CITY OF ALBUQUERQUE

**RE: Paseo and Kimmick East
99999 Valiente Rd NW
Conceptual Grading & Drainage Plan
Engineer's Stamp Date: 08/26/2025
Hydrology File: C11D010
Case # HYDR-2025-00311**

Based upon the information provided in your submittal received 08/27/2025, the Conceptual Grading & Drainage Plan is preliminary approved for action by the Development Facilitation Team (DFT) / Development Hearing Officer (DHO) on Site Plan for Building Permit and platting action.

PASEO AND KIMMICK EAST
ALBUQUERQUE, NM
CONCEPTUAL GRADING
AND DRAINAGE PLAN

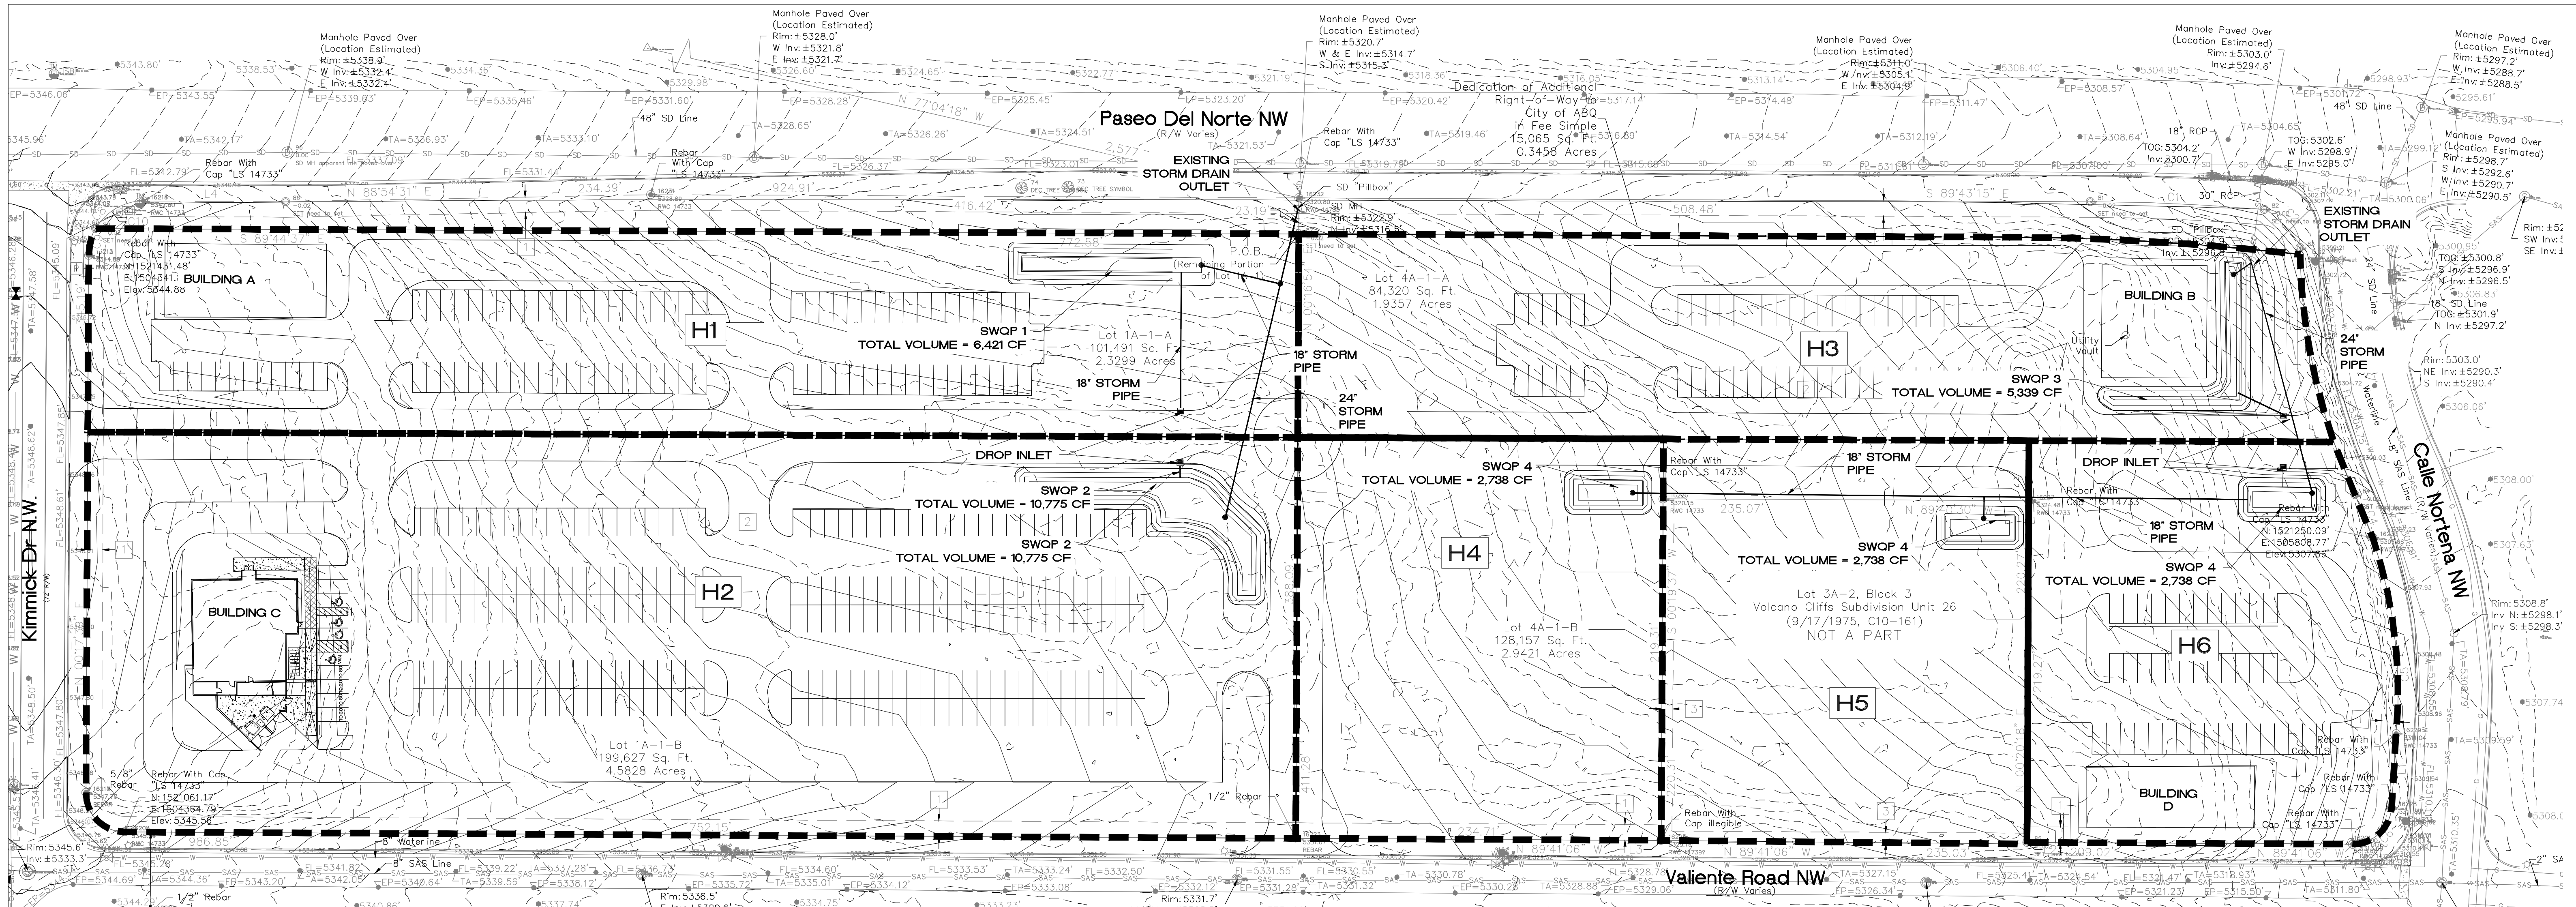
1. Please submit a more detailed Grading & Drainage Plan to Hydrology for review and approval.
